SOUTH CAROLINA ELECTRIC & GAS COMPANY

Subject: Virgil C. Summer Nuclear Station  
Docket No. 50/395  
Solid Radwaste Handling and  
Disposal - Open SER Item 1.7.17

11.5 SOLID WASTE SYSTEM

SOUTH CAROLINA ELECTRIC & GAS CO.  
 VIRGIL C. SUMMER NUCLEAR STATION  
 Solid Waste Disposal  
 Figure 11.5-1  
 (CAI Desg. D-302-732)

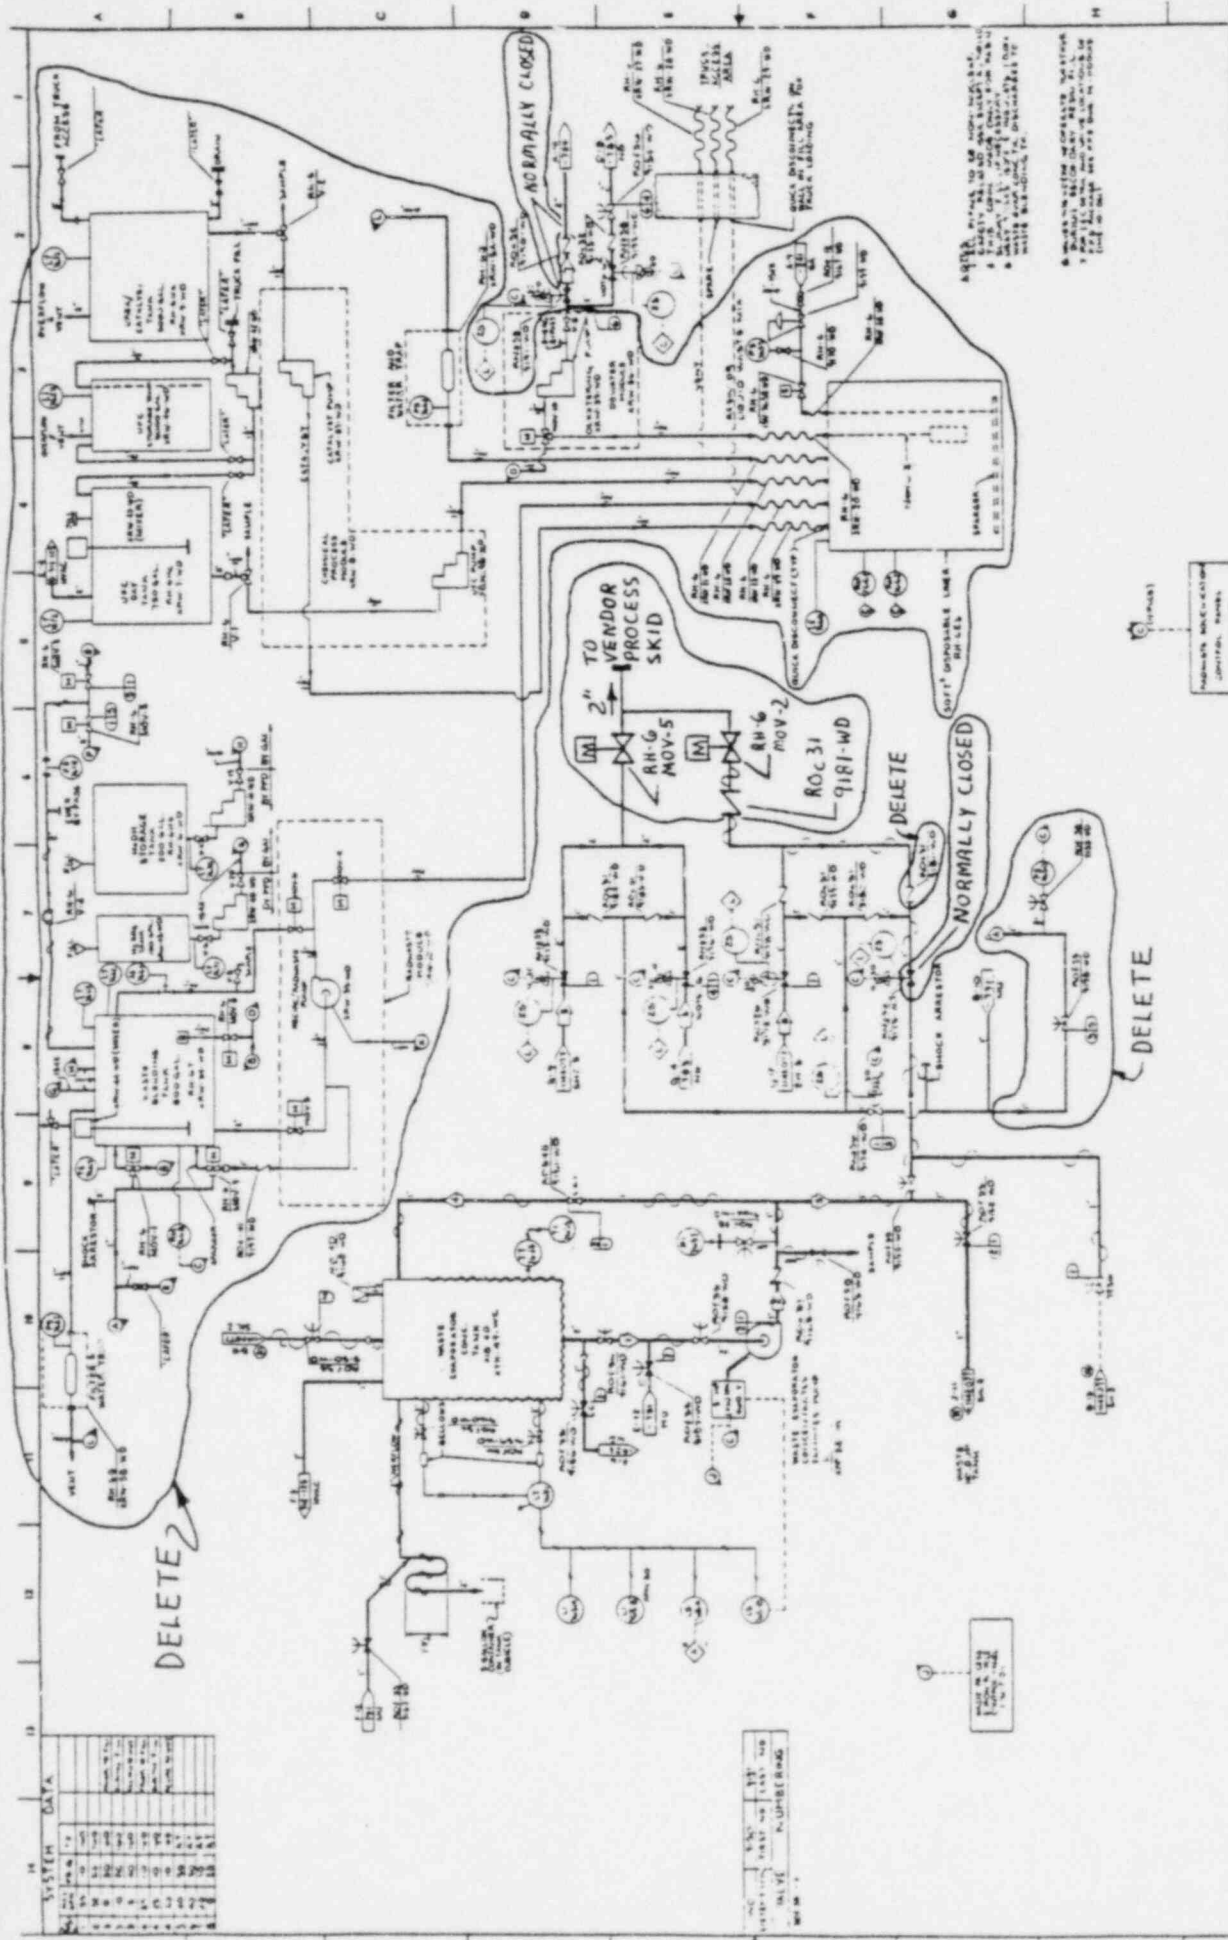
The filling, flushing and solidification process is performed automatically or remote manually from a control panel in a shielded room. Figure 11.5-1 is a flow diagram of the system. A layout of this area is given by Figure 1.2-25.

Radwaste solidification is accomplished using a portable cement solidification process supplied by Chem Nuclear Systems Inc. Liquid waste contained in the Chemical Drain Tank and Waste Evaporator Concentrates Tank is recirculated using their respective pumps and a sample is taken. This sample is used in the Process Control Program to determine pH adjustment, waste/binder ratio, and for the purpose of test solidification. Liquid waste is transferred to the fill head and into the liner located in the solidification area. Correct pH range based on the test solidification is accomplished by adding calcium hydroxide through the fill head to the liner. Bulk cement and calcium hydroxide are stored in a bulk trailer outside the Auxiliary Building truck access. Other conditioning chemicals may be added if necessary from the conditioning chemical tank and transfer pump.
